Re: Riverfront Trails Annexation, Rezoning, Growth Policy Amendment, and Subdivision 2nd Sufficiency Review

MEMO

2ND SUFFICIENCY REVIEW SUBMITTAL
AUGUST 1, 2022

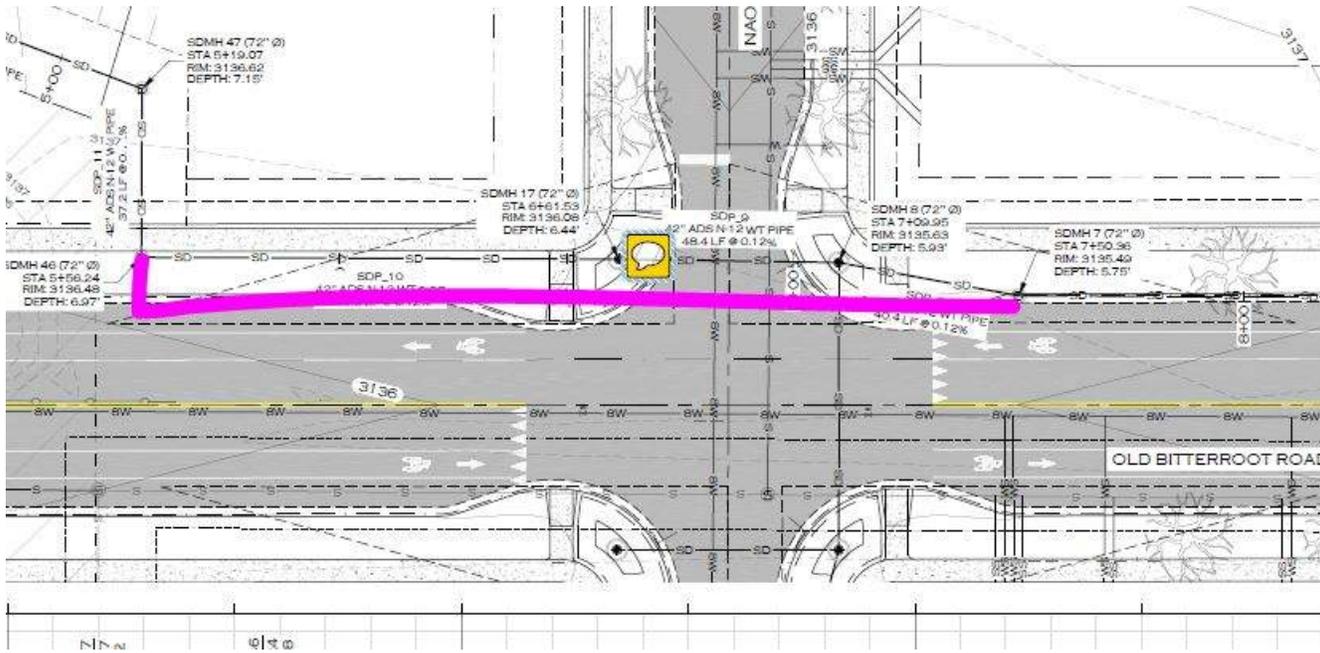
Page: 205 Author: Andy Schultz (SchultzA@ci.missoula.mt.us) Subject: Sticky Note Date: 6/9/2022 4:07:27 PM
is there easement or r/w up here?

Page: 205 Author: Adam Marsh (MarshA@ci.missoula.mt.us) Subject: Sticky Note Date: 6/14/2022 5:41:11 PM
Make sure pipe joint deflection is not more than 50% of manufacturer recommendation

Should this water main extend north?

I don't think that we can require them to
